HARDWARE ERRATA REPORT

P/N PBA-B-01

phyFLEX Baseboard

Revision A1, 14 February 2014

Figure 1: Errata 01 Rework

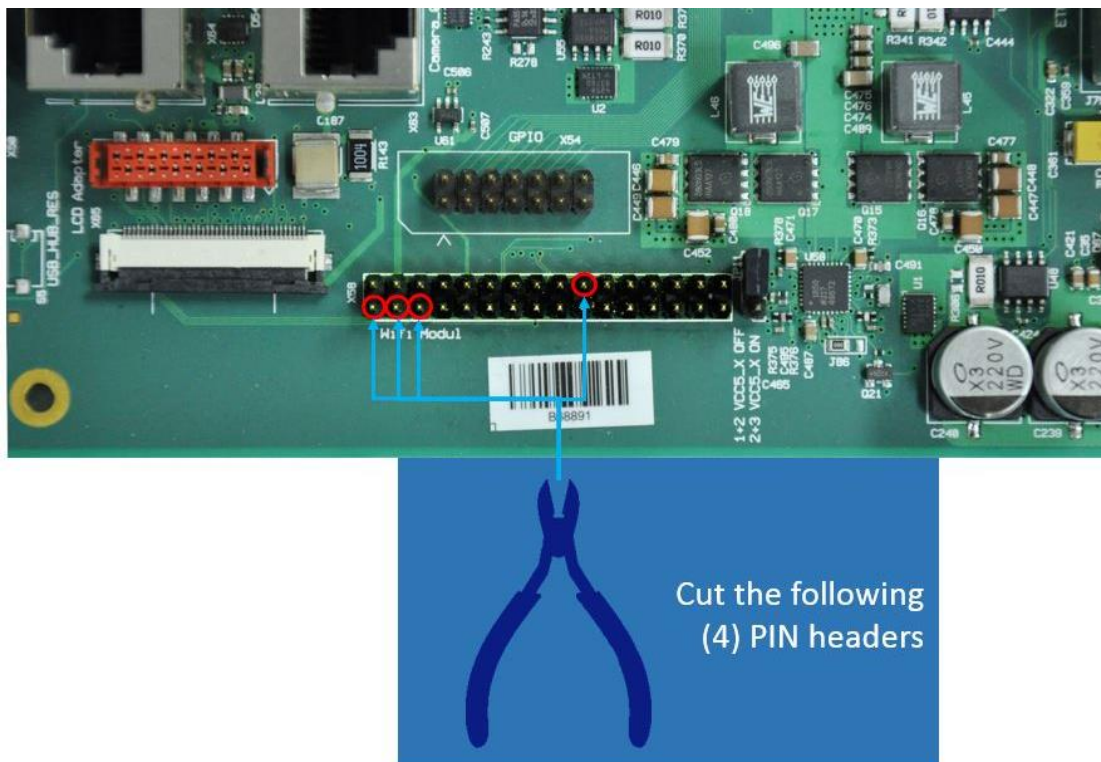
Errata Impact: The i.MX6 fails to boot from SPI NOR Flash when the WiFi module (PCM-958) is connected.

Errata Description: The Baseboard routes SPI0 signals to the WiFi module connector X58. When the WiFi module (PCM-958) is connected to the Baseboard the SPI0 signal voltage lowers. Since the SPI0 signals are connected to the i.MX6 SOM on-board SPI Flash the board will fail to boot from SPI Flash.

Workaround: Hardware rework is required to disconnect the SPI0 signals from being routed to the WiFi module. On the Baseboard cut the SPI pin headers 1, 3, 5, and 20 at X58. Figure 1 below shows which pins must be cut before inserting the WiFi module.

Errata Fix: Planned for Q2 2014

Figure 2: Errata 02 Rework

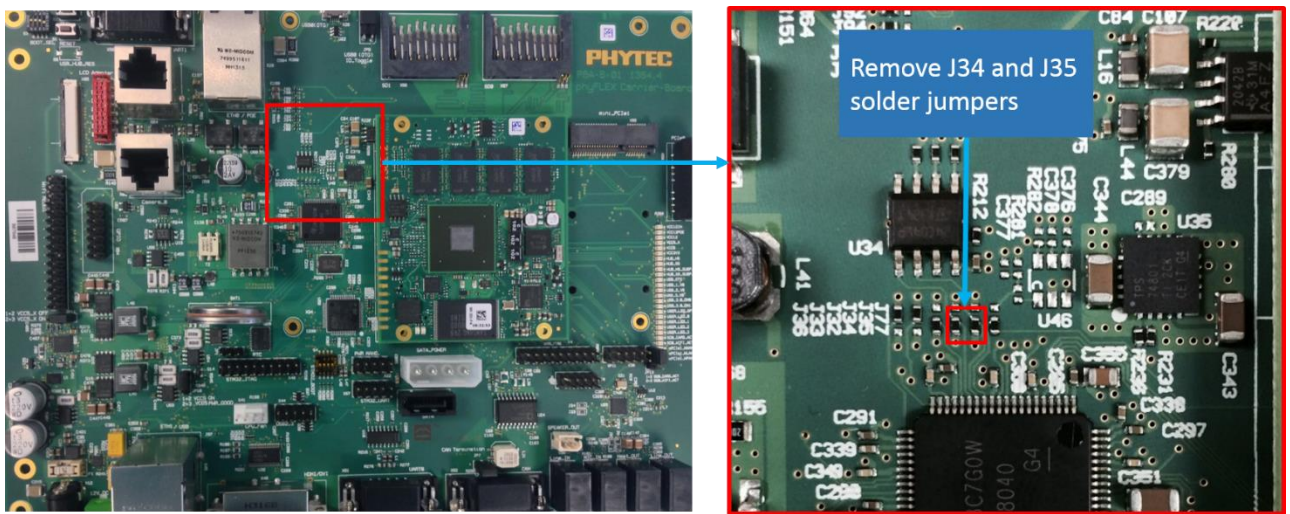
Errata Impact: USB devices plugged into X45 fail to be recognized by the i.MX6.

Errata Description: The pull-up resistors connected to the serial clock terminal (SCL_SMBCLK) and serial data terminal (SDA_SMBDAT) on the TUSB8040 USB Hub indicate that an I2C EEPROM is connected. However, because the EEPROM on the baseboard is empty the TUSB8040 will go into and stay in programming mode. This results in the TUSB8040 reporting as a programming end point to the USB Host controller and not being able to recognize the connection of USB devices.

Workaround: Set the TUSB8040 to indicate that an EEPROM is not connected by removing the pull-up resistors on the SCL_SMBCLK and SDA_SMBDAT signals. To do so, perform hardware rework to remove J34 and J35 solder jumpers on the baseboard. Figure 2 below shows which resistors must be removed.

Errata Fix: 1364.5
